Point Erin Tunnel

Response to s92 request: Landscape and Visual effects - further clarification questions

Figure 1.1: Looking towards plant room and retaining wall location from within Point Erin Park

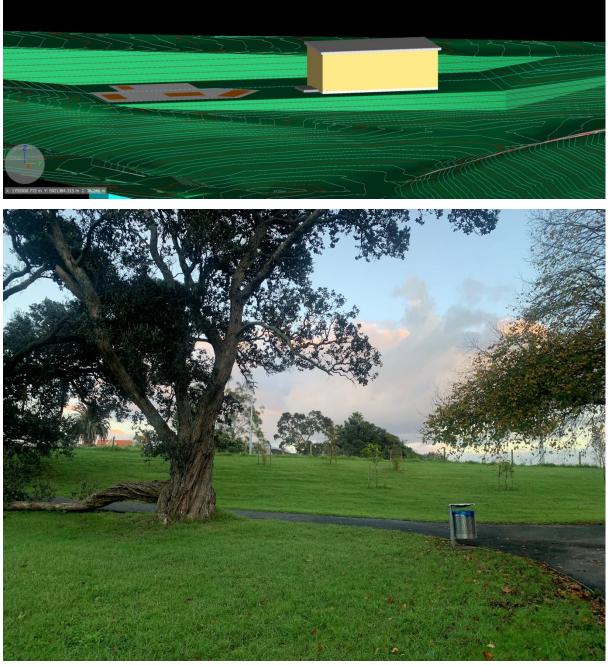
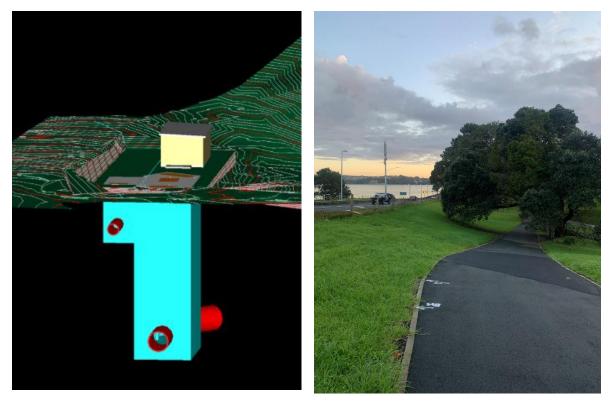
The applicant is asked to provide some additional model views of the south-west corner site as seen at a pedestrian level walking into the site and walking out of the site from the existing footpaths (loop path that goes north and path that goes east). They do not need the site photo behind them if one is not available- or if one is available, they can provide the photo and model view separately to enable ease of reading.

The 3D Design model has limitations on how it can be viewed, as it is not intended to be a visual simulation tool. As such, it is not possible to generate images within the model of views at pedestrian level. However, to provide some additional context to the likely appearance of the permanent above-

ground infrastructure, additional captures from the model are provided below, along with some photos from Point Erin Park looking towards the embankment which will be retained.

Planting Intent - Lower Terrace.

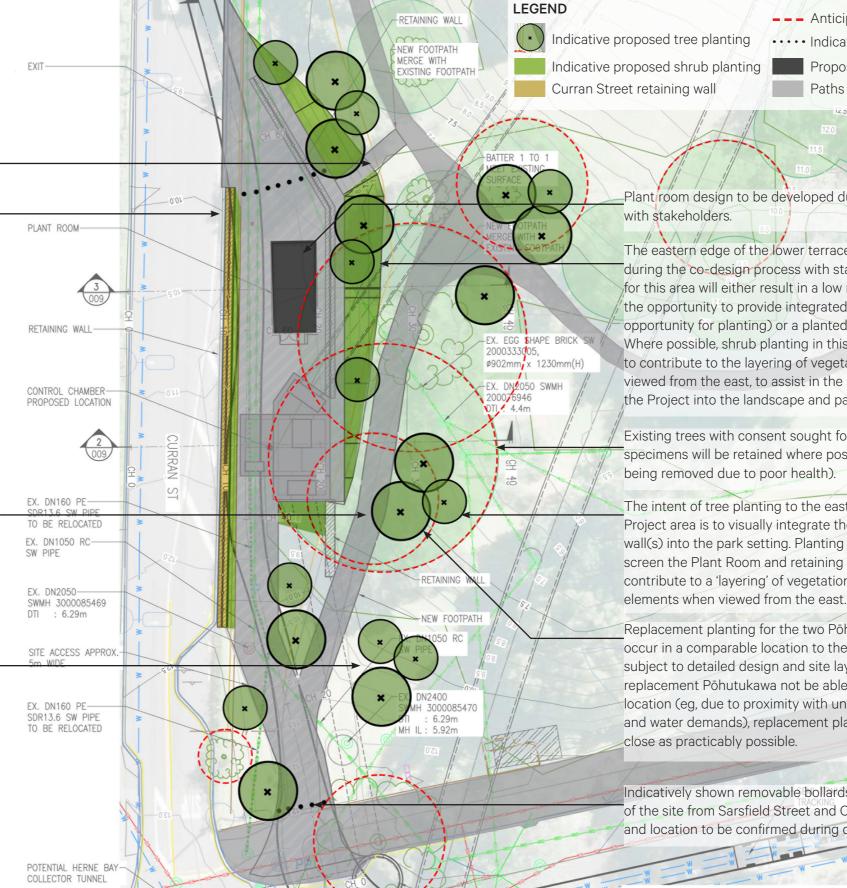
• I am not convinced that there is space to integrate the tall western wall (along Curran Street) with planting, and that reliance on materials/colour is unlikely to suitably mitigate and integrate the height of the wall (up to 4m high). – I understand from the meeting that there is space for low plants and climbers- it would be good if this was more clearly shown on the plan or provided somehow in writing – e.g., outcomes sought include x, y, z.

• I understand the final details will be worked through with Council (Parks) and mana whenua, however the indicative planting plan provided does not convince me that there is suitable space to screen a high retaining wall (up to 2-3m) along the boundary, and that reliance on material/colour is unlikely to be able to achieve an appropriate outcome from a landscape perspective. – See comments above regarding providing notes on the landscape plan about the planting intent for retaining walls.

An updated indicative planting plan has been included, which more clearly articulates the objectives of planting (Appendix B). The plan demonstrates that there is space available for shrubs and/or climbers along the retaining wall, which would serve to 'break-up' the continual expanse and scale of the wall, and provide a layering of vegetation in combination with tree and shrub planting to the east of the plant room. Planting efforts will be focussed on those parts of the wall that are greater than 1.5m in height. Parts of the wall which are lower in 1.5m in height (and are of a more pedestrian scale) will be mitigated by the planting to the east and south of the lower terrace area.

The Curran Street retaining wall is to be designed and detailed during a co-design process with stakeholders. The height of the retaining wall will be no greater than 3m, tapering to ground level to the north and south (with much of the retaining wall being less than 1m in height). The intent of planting along the retaining wall (climbers / vine / shrub) is to 'break-up' the continual expanse and scale of the wall, and provide a layering of vegetation in combination with tree and shrub planting to the east of the plant room. Planting along the retaining wall should be focussed on those parts of the wall that are greater than 1.5m in height. Parts of the wall which are lower in 1.5m in height (and are of a more pedestrian scale) will be mitigated by the planting to the east and south of the lower terrace area.

The intent of tree planting to the south of the lower terrace Project area is to visually integrate the plant room and Curran Street retaining wall into the landscape when viewed from the south (including properties along Sarsfield Street). Planting is not intended to entirely screen views of the Project, and is to give consideration to potential conflicts with underground infrastructure. Tree planting to the south of the lower terrace should provide an entranceway into the park.
